ENVIRONMENTAL PROTECTION AGENCY**40 CFR Part 52**

Approval and Promulgation of Implementation Plans; North Dakota; Regional Haze State Implementation Plan; Federal Implementation Plan for Interstate Transport of Pollution Affecting Visibility and Regional Haze**AGENCY:** Environmental Protection Agency (EPA).**ACTION:** Final rule.

SUMMARY: EPA is partially approving and partially disapproving a revision to the North Dakota State Implementation Plan (SIP) addressing regional haze submitted by the Governor of North Dakota on March 3, 2010, along with SIP Supplement No. 1 submitted on July 27, 2010, and part of SIP Amendment No. 1 submitted on July 28, 2011. These SIP revisions were submitted to address the requirements of the Clean Air Act (CAA or Act) and our rules that require states to prevent any future and remedy any existing man-made impairment of visibility in mandatory Class I areas caused by emissions of air pollutants from numerous sources located over a wide geographic area (also referred to as the "regional haze program"). EPA is promulgating a Federal Implementation Plan (FIP) to address the gaps in the plan resulting from our partial disapproval of North Dakota's Reg

Figure 1. Coal-Fired Boilers Operating Below 0.17 lb/MMBtu

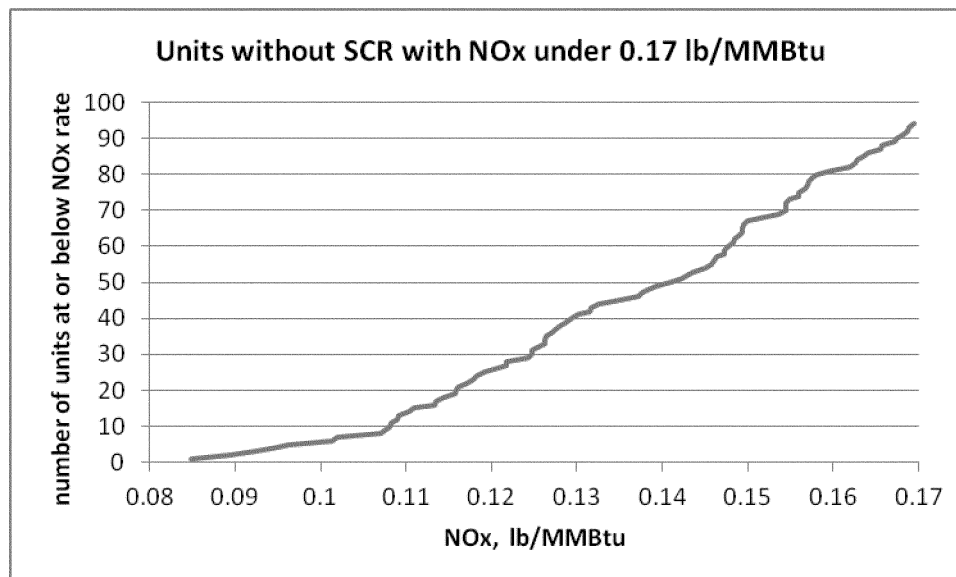
Analysis of emissions data found significant discrepancies in Figures 2.2 and 2.3 of GRE's November 2011 Refined Analysis. A review of EPA Title IV data for 2010 showed 94 coal-fired boilers that do not have SCR achieve annual emissions levels below 0.17 lb/MMBtu, with the median slightly under 0.14 lb/MMBtu (see Figure 1 below). Of these, ten of them are using SNCR in combination with combustion controls to achieve under 0.17 lb/MMBtu. See docket for a list of these facilities. Of these ten, three are supercritical tangentially-fired boilers that use lignite coal with emissions below 0.14 lb/MMBtu. These include Big Brown 1 and Monticello 1 and 2, as discussed earlier in our responses. In addition, the NEEDS Database v.4.10 for the Final Transport Rule in the CSAPR docket includes two tangentially-fired coal/steam units from North Carolina with LNC3 and SNCR that had emission rates of 0.159 lb/MMBtu and 0.164 lb/MMBtu.

As we explain elsewhere, we have decided to revise the BART limit from 0.12 lb/MMBtu to 0.13 lb/MMBtu on a 30-day rolling average.
